Sequoyah Nuclear Plant, Unit 1  
Facility Operating License No. DPR-77  
Docket No. 50-327

**Subject: Response to NRC Request for Additional Information Regarding the Heavy Load Lifts and UHS One Time Change in Support of Unit 2 SGRP (TAC NO. ME7225)**

#### RESPONSE TO REQUEST FOR ADDITIONAL INFORMATION REGARDING THE HEAVY LOAD LIFTS AND UHS ONE TIME CHANGE IN SUPPORT OF UNIT 2 SGRP

### Figure 1 – Model Change for Load Drop

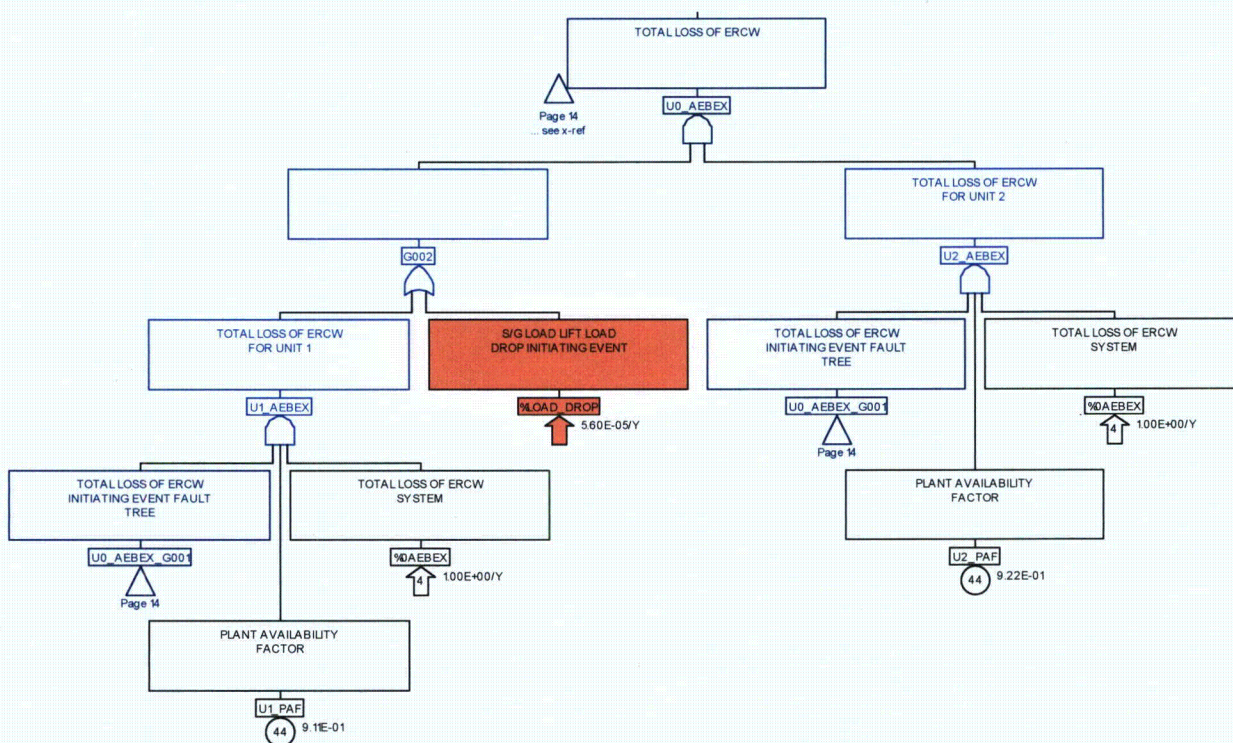
*In the submittal, the licensee has identified the change in risk associated with the requested ERCW alignments as  $7.2E-7$ /year (CDF) and  $4.05E-8$ /year (LERF); this is the risk increase above the nominal risk of maintaining the normal ERCW alignment. Also, the licensee has identified the additional risk of performing heavy load lifts as  $7.0E-9$ /year (CDF) and  $5.0E-10$ /year (LERF), given that the ERCW is in its proposed special alignment. The risk increase incurred due solely to the special ERCW alignment is two orders of magnitude greater than the heavy load lift risk increase. It is assumed by the NRC staff that if the ERCW is not aligned as described, then the risk increase associated with the heavy load lifts would be significant, or at least greater than the  $7.2E-7$ /year (CDF) and  $4.05E-8$ /year (LERF) reported for the ERCW alignment. However, the risk metrics associated with performing the same heavy load lifts with ERCW in its normal alignment was not provided in the submittal, which would permit the NRC staff to assess the relative risk impacts. Therefore, the NRC staff cannot conclude that the special ERCW alignment is necessary to avoid a more significant risk increase during the heavy load lifts.*

*The licensee is requested to justify the need for the ERCW alignment and the resulting risk increases incurred by providing the risk metrics associated with heavy load lifts if the normal ERCW alignment is maintained.*

For the SGRP, all the postulated accidents and system alignments are covered in the PRA model. The PRA model is based on the as built, as operated plant design and can be used to evaluate a possible load drop event by applying specific modeling changes. A detailed analysis of where a load drop can occur and what systems can be affected is documented in the SQN Unit 2 Steam Generator Replacement Rigging and Heavy Load Handling Technical Report (Reference 5).
